Work Order ID 69248

Item ID: D412-664-203TRN

Item Name: Crosstube Turning Detail

DRAWING NO. D412-664-243	TITLE CROSSTUBE ASSEMBLY (412 HI AFT)	REV. E	DART AEROSPACE LTD ENGINEERING ORDER		D.E.O. NO. D412-664-243-E-1	SHEET NO. SHEET 1 OF 2	SCALE NTS
DRAWN	CHECKED	MFG. APPR.	APPROVED	DE APPR.			
DATE 11.03.31	DATE 11/03/31	DATE 11.03.31	DATE 11/03/31	DATE 11.03.31

**D412-664-243
ASSEMBLY DETAIL**

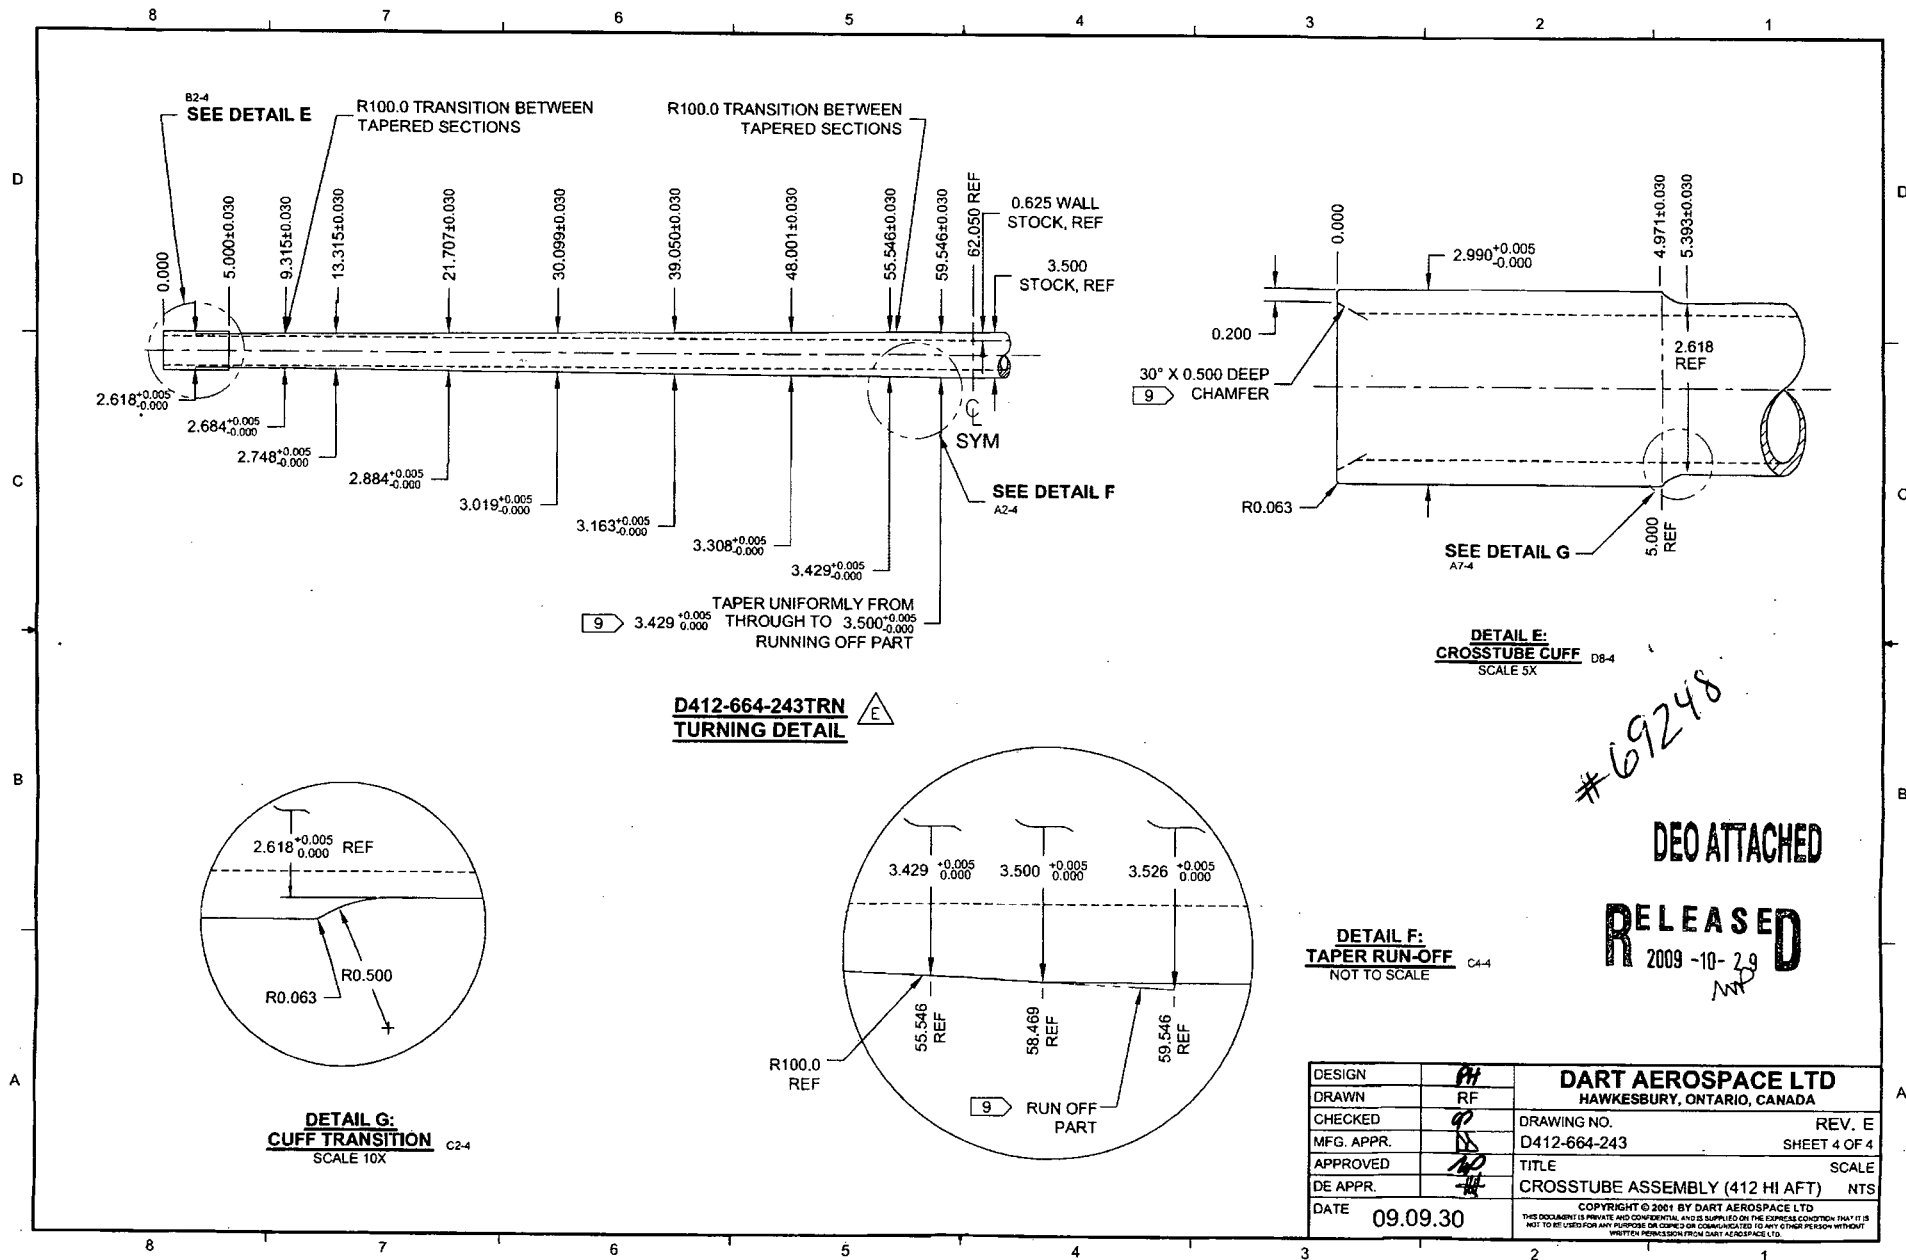
PURPOSE:

REMOVED ABRASION STRIP IN FAVOR OF A THIN LAYER OF PROSEAL 890.

IS:

D3189-1 CHAFING SHIELD (1, INSTALLED OVER PROSEAL 890)
MS21920-28 CLAMP, 2X
2 PL

WAS:

D2856-600-1009 ABRASION STRIP
D3189-1 CHAFING SHIELD (1, INSTALLED OVER ABRASION STRIP)
MS21920-28 CLAMP, 2X
2 PL

2
MASK AREA PRIOR TO PAINTING AND
APPLY CLEAR COAT AFTER PAINTING
